Project

125 Boston Harbor Home

FIELD REPORT

Report No.

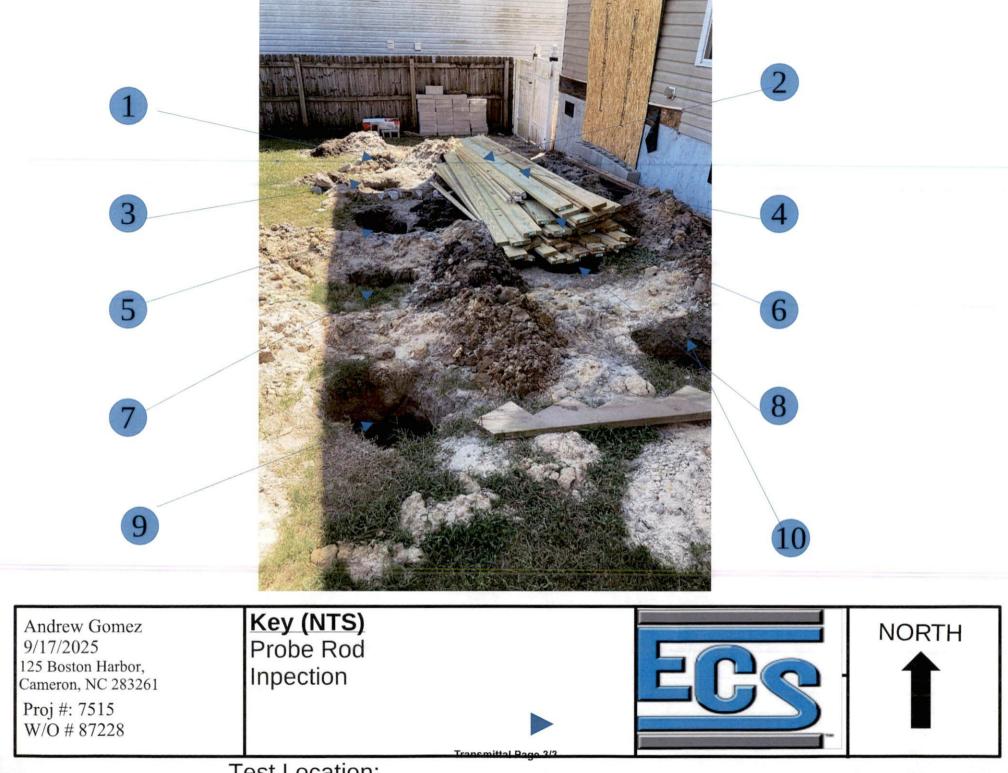
The undersigned arrived on site, as requested, to observe conditions of porch pier excavations. A total of 10 excavations (planned depth was 3 feet below adjacent grade) were observed. Using a steel-tipped rod, the bottom of the excavations were probed to determine stability. Several excavations had standing water. Below are our observations of each location, also shown on the attached site plan:

Excavations 1 and 4 - pump out water prior to pouring concrete.

Excavations 2, 6, 7, and 10 - undercut 1 foot below bottom of planned foundation elevation and replace with 57 stone wrapped in non-woven geotextile fabric.

Excavations 3, 5, 8, and 9 - undercut 2 feet below bottom of planned foundation elevation and replace with 57 stone wrapped in non-woven geotextile fabric.
